Groundwater Application Review Summary Form

Application # G- 18748

GW Reviewer Grayson Fish Date Review Completed: 8/14/2023

TO: Water Rights Section Date 8/14/2023
 FROM: Groundwater Section Grayson Fish
 Reviewer's Name
 SUBJECT: Application G- 18748 Supersedes review of 6/15/2020
 Date of Review(s)

Well Location Map

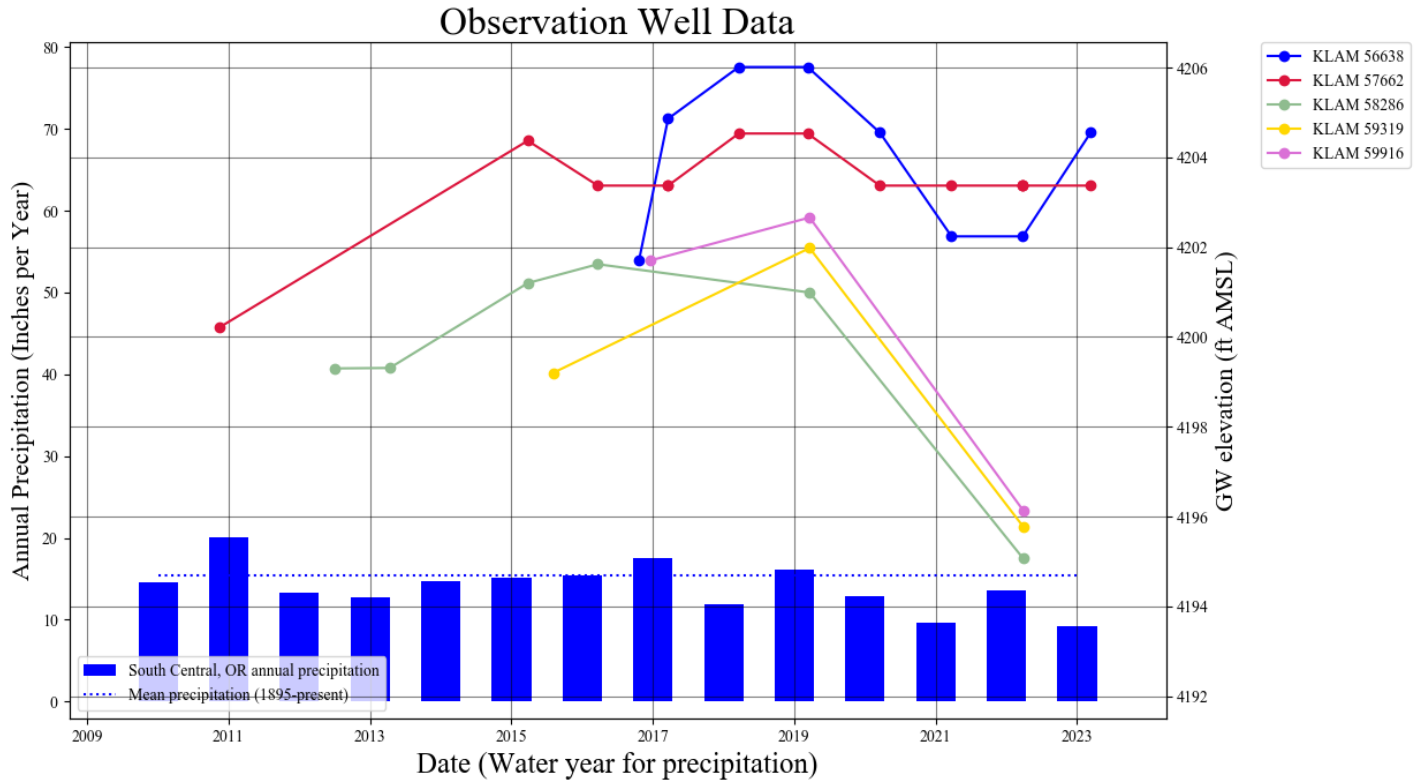
- B3. **Groundwater availability remarks:** Water level data within the Wood River basin near the proposed POA are relatively limited. Irrigation wells KLAM 56638, KLAM 57662, KLAM 58286, KLAM 59319 and KLAM 59916 located approximately 2 miles north of the proposed POA have water level data from permit condition reporting. KLAM 56638 and KLAM 57662 show relatively stable groundwater elevations (both are flowing artesian). It should be noted that KLAM 56638 was deepened (deepening report KLAM 59741) to 695 feet bls but is only sealed to 39 feet bls. Other wells noted are sealed to a minimum depth of 467 feet bls. Reported groundwater elevations for KLAM 58286, KLAM 59319 and KLAM 59916 show a ~6 foot decline between 2019 and 2022, losing flowing artesian conditions. The recent groundwater level declines reported in the above-mentioned wells do not meet the definition of excessively declining or excessively declined and, therefore, a preponderance of evidence does not exist to say that groundwater is over-appropriated.

There are also only a few existing groundwater rights in the area and the nearest is approx. 2 miles north of the proposed well. However, transmissivity in this part of the Wood River basin aquifer system is generally high and storativity is generally low so injury at 2 miles is possible but cannot be determined within a reasonable uncertainty to make a positive finding of injury, so in addition to static water level reporting, the Large Water-Use condition, and the special condition described below are recommended.

B1(d)-iii Special Condition:

The well shall be equipped with an access port at the well head that is at least 1 in diameter and allows direct access to the water column. The permit holder shall allow Department staff access to the well for the purposes of obtaining water-level measurements and recording water use.

Stream-Depletion Model Results

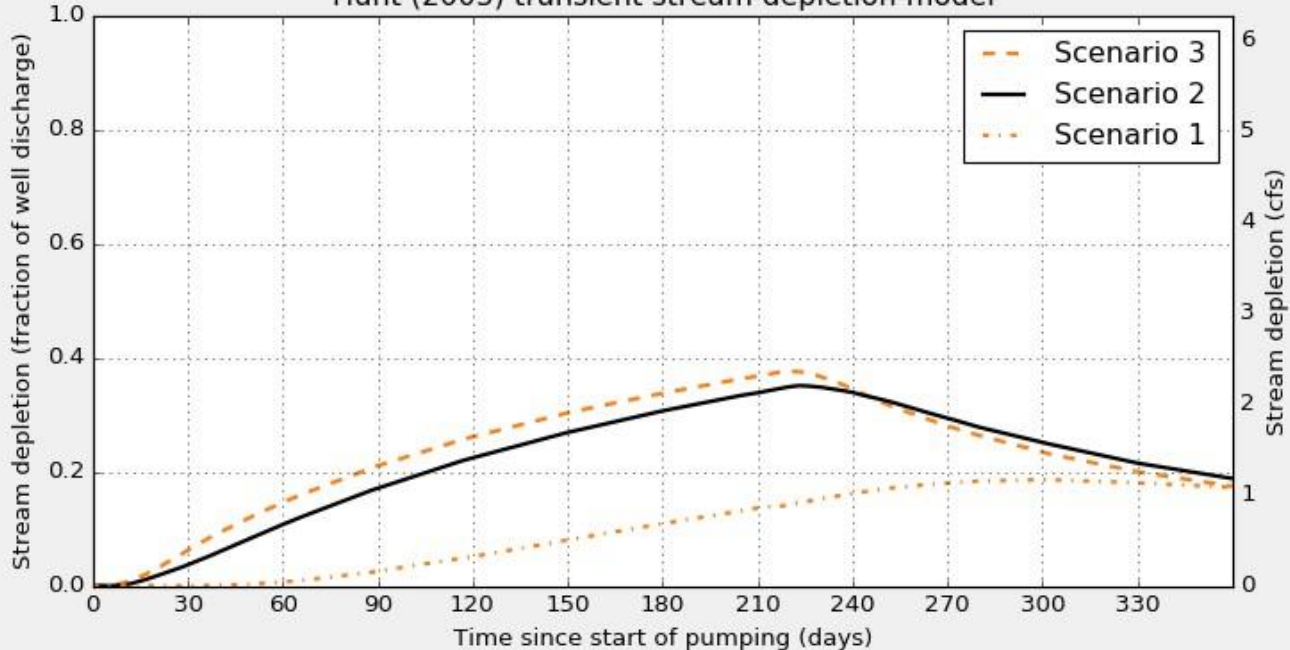
Basis for impact evaluation: Stream-depletion was estimated using the Hunt (2003) stream-depletion model with parameter values informed by Gannett et al. (2012) and using methods previously used by the Department for estimating stream-depletion in the Klamath Basin.

C6. **SW / GW Remarks and Conditions:** The applicant's proposed POA would be producing from an aquifer that has been found to be hydraulically connected to surface water in the Klamath Basin, Wood River Subbasin, at a distance of greater than 1 mile. However, the proposed rate and estimated stream-depletion does not lead to an automatic assumption of PSI per OAR 690-009.
